## MEMORANDUM

TO: Mr. Chris Larson, Approving Officer, City of Salmon Arm  
FROM: Dave Sonmor, P.Eng, Civil Engineer

### **Subject: 370 – 20<sup>th</sup> Street SE - PLR file number 24.04 Variance Request**

**EXISTING STORM MAIN**

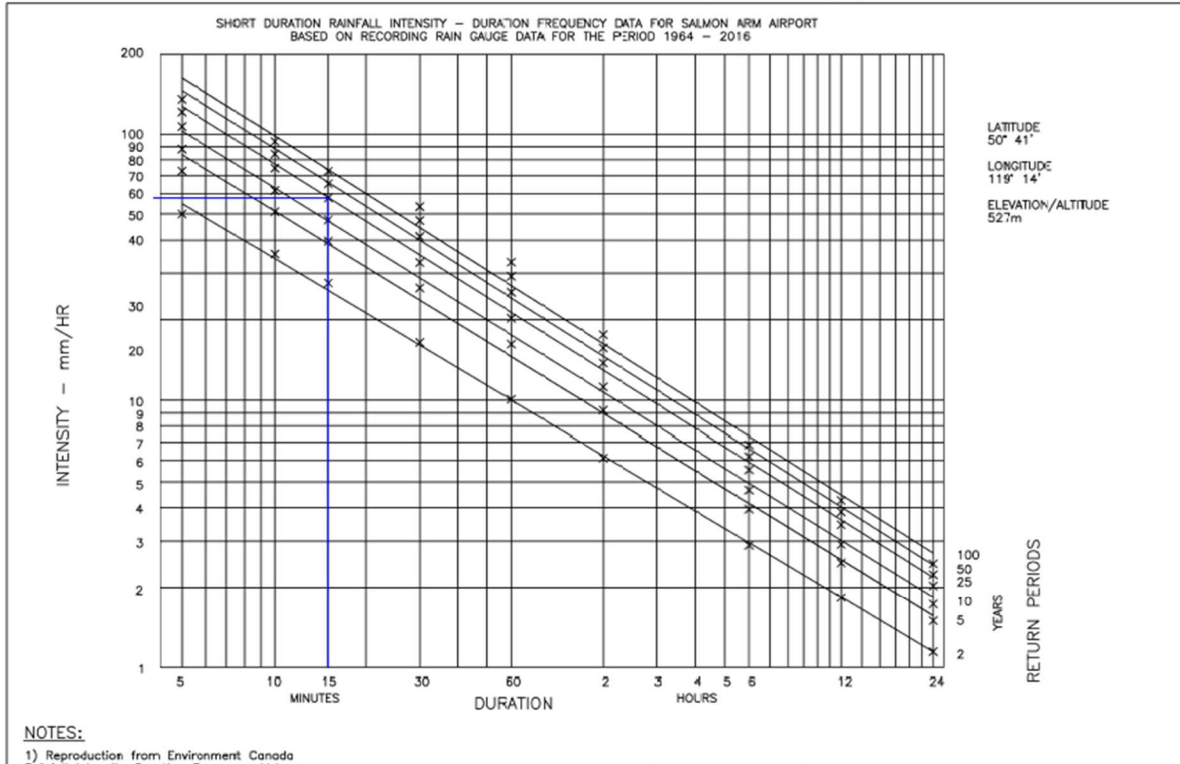
- 2) It is in LELs opinion that, due to location and topography, the existing 200mm storm main is of sufficient capacity to accommodate runoff from the 25 year storm event. The existing 200mm main is approximately 45m in length and currently services a combined catchment area of approximately 1 hectare. As the subject main is located at the top of a local highpoint and in a developed residential area, limited potential exists for dramatic increase in impermeable area. LEL performed flow calculations as per the City of Salmon Arm Bylaw 4293 demonstrating that under the current, fully developed site conditions, the existing main has the capacity to service the entire catchment area without need for current or future upgrades. Under existing conditions, a Tc value of 15 minutes, a 25 year rainfall intensity of 58 mm/hr + 10%, a runoff coefficient of 0.55, and a catchment area of 0.95 hectares were used to calculate a total 25 year runoff rate of approximately **93 L/sec**. the existing pipe was then reviewed for capacity. With an estimated slope of 8%, a Mannings n value of 0.011, and pipes flowing at 75% full, the existing 200mm storm main has the capacity to convey approximately **100 L/sec**, exceeding the anticipated 25 year run off. For the reasons listed above it is in LELs opinion that the existing storm main does not require upgrades to function as intended and that cash-in-lieu payment for future upgrades of the existing storm main should be eliminated as a condition of subdivision.

Waive the requirement to provide cash-in-lieu payment towards future upgrade of the existing 200mm storm main located along the eastern parcel line.
